DART SERVICE INSTRUCTION TO AMEND INSTALLATION INSTRUCTIONS II135-21 REV. J

AND INSTRUCTIONS FOR CONTINUED AIRWORTHINESS ICA135-21 REV. F OR LATER APPROVED REVISIONS

DRAWING NO. CHECKED MB **DSI 9892** MFG. APPR. N/A **APPROVED** SAD DE APPR. DS

TITLE L-BRACKET SUBSTITUTION

FIGURE 1: LOCATION OF REPLACEMENT L-BRACKET

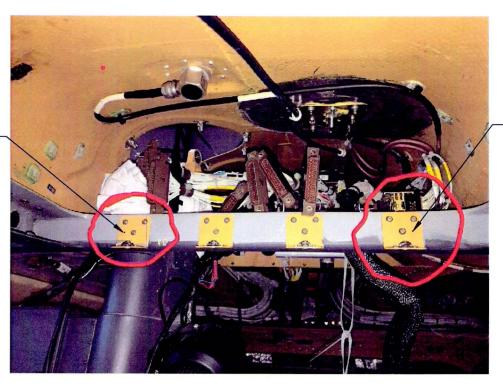
It has come to Dart's attention that on some early model EC135, the presence of a 12VE CM Panel may prevent installation of the upper cutter fixed provisions as part of the DART EC135 647.7300 Series Cable Cutter Kits as intended. See Figure 1 of this DSI.

REMOVE AND REPLACE WITH CUSTOM L-BRACKET

REMOVE AND REPLACE WITH CUSTOM L-BRACKET

- 2.1 Remove the two intefering L-Brackets identified in Figure 1.
- 2.2 Fabricate two new L-Brackets per Figure 2 and 3 using 0.063 thick 2024-T3 aluminium sheet per AMS-QQ-A-250/4 or ASTM B209.

FIGURE 4: L-BRACKET ASSEMBLY

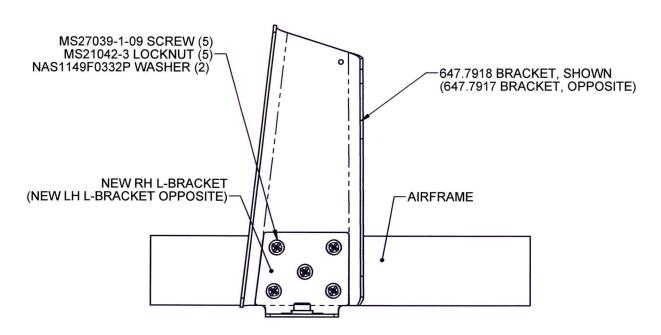
- 2.3 Locate Brackets 647.7917/.7918 per Figure 4 of II135-1 and locate the newly fabricated L-Brackets to match those removed in step 2.1.
- 2.4 Transfer drill qty (3)x existing holes from the airframe to the newly fabricated L-Brackets and 647.7917/.7918 Brackets. Drill qty (2)x additional holes on the newly fabricated L-Brackets and 647.7917/.7918 Brackets for a total of 5 mounting holes on each set of brackets as shown in Figure 4. Transfer the location of the nutplate hole to the replacement L-bracket.

- 2.7 Install nutplate P/N LN29679AM5 using qty(2) rivets P/N DIN65379-2404E on each manufactured L-Bracket.
- 2.8 Attach replacement bracket to the airframe using F/N 9 P/N MS27039-1-09 Screws, F/N 97 P/N MS21042-3 Locknuts, and F/N 101 NAS1149F0332P Washers with 647.7917/647.7918 Bracket per Figure 4.
